**RE: Big Bend Transfer Company Solid Sulphur Handling Air Pollution
Construction Permit Application -
Information and Request for Notice of Proposed Agency Action**

COMPLETENESS ASSESSMENT

**Application for Air Construction Permit
2.24 Million Tons per Year
Solid Sulfur Storage and Handling Terminal**

**Stephen Smallwood, PE
Air Quality Services**

Big Bend with baghouses on Agrico property, Additional Batch Drop in Ship Unloading Operation and Paved Road.

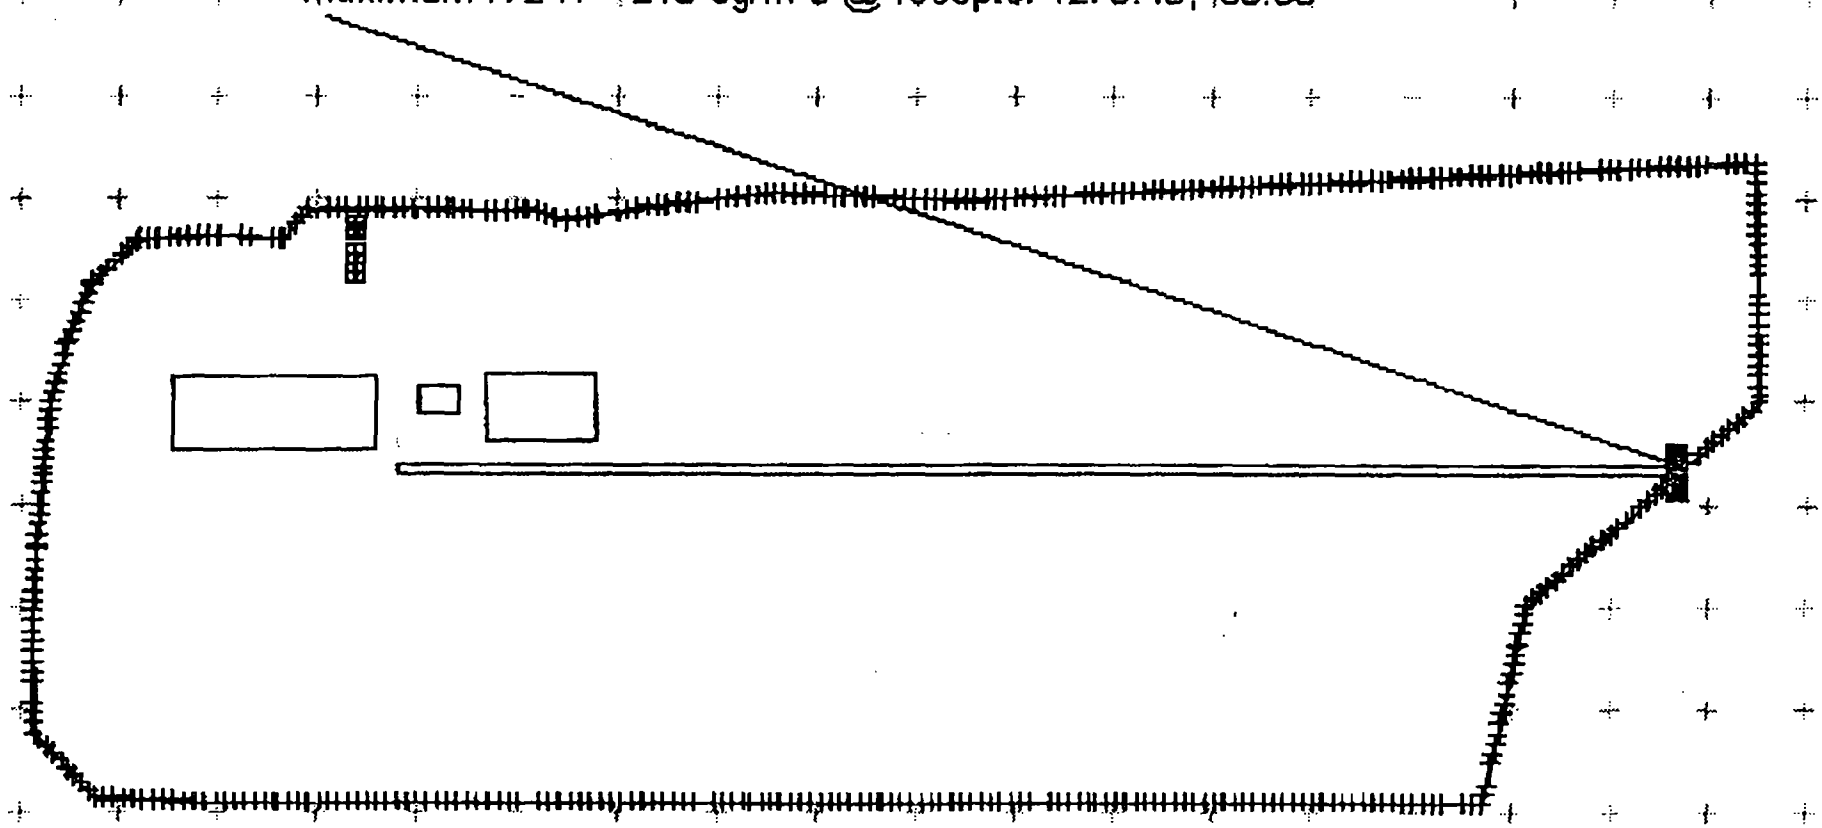
- (a) The 24-hour National Ambient Air Quality Standard is based on the fourth highest concentration in any three rolling calendar years.
- (b) All receptor locations are in (x,y) coordinates in meters relative to the location of the BBTC Package Boiler Source #8.
- (c) This location is over the water next to the ship along the northern property boundary.
- (d) This location is at ground level at the plant paved road entrance gate to the BBTC facility

Maximum H₂H = 218 ug/m³ @ receptor 1270.40, 60.80.*

Big Bend with Sulfur Specific Batch Drop Emission Factor, Additional Batch Drop in Ship Unloading Operation, Paved Road, and Additional Material Transfer Operation and Pile Maintenance in Solid Sulfur Storage Building.

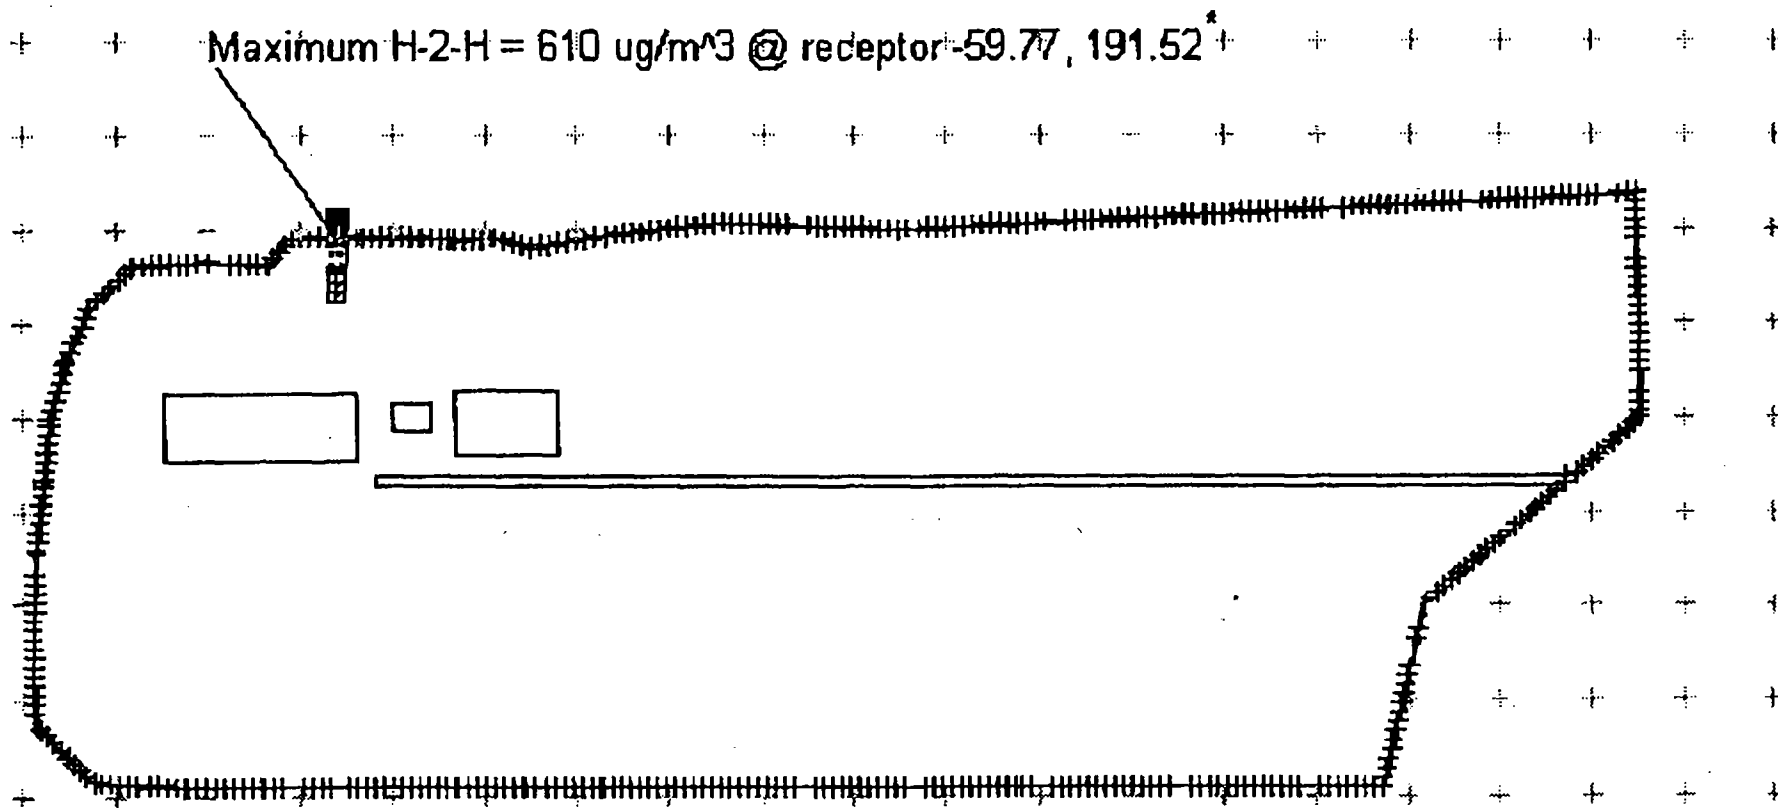
- (a) The 24-hour National Ambient Air Quality Standard is based on the fourth highest concentration in any three rolling calendar years.
- (b) All receptor locations are in (x,y) coordinates in meters relative to the location of the BBTC Package Boiler Source #8.
- (c) This location is over the water next to the ship along the northern property boundary.
